Consultation Response from KC Landscape
2026/90232 - New Mills, Brougham Road, Marsden, Huddersfield, HD7 6AZ
Redevelopment of mill complex of 11,584sqm for mixed use development, including building demolition, site clearance, site remediation works, the removal of buildings and floor slabs to open up the River Colne, repairs to retained buildings, conversion of lower ground floor of western mill to Class E (food and non-food retail, restaurant and cafe), new buildings providing light industrial / R&D uses (limited to Use Classes Eg(ii)(iii)), the alteration and repair of an office building (Use Class Eg(i)), the creation of a new public square and associated hard and soft landscaping, circulation and servicing space, car parking and ancillary structures
Date Responded: 01/06/2026
Responding Officer: KC Landscape
Responding Ref: QQ25

Section C

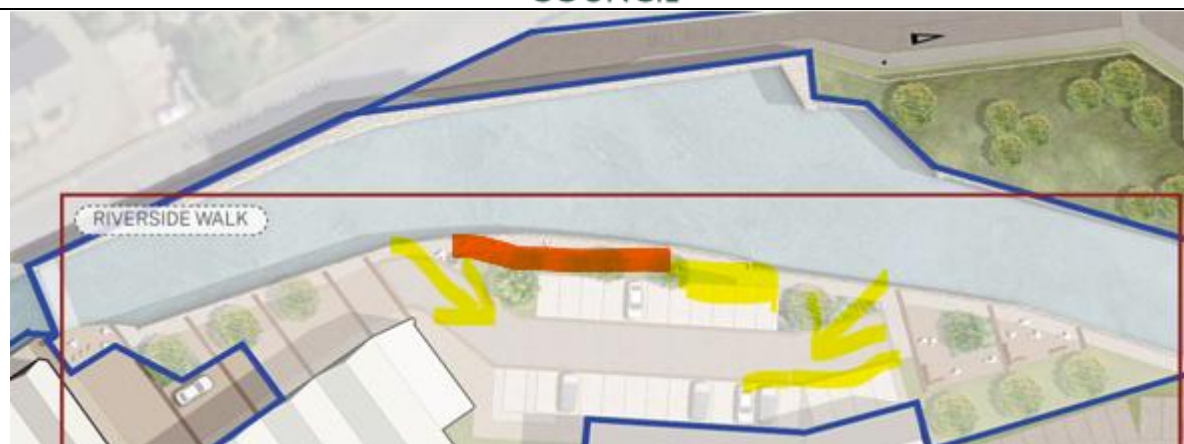
Section C doesn't seem to reflect the car parking which will be relatively close by to the riverside walk and viewed from the path, particularly where the wall is.
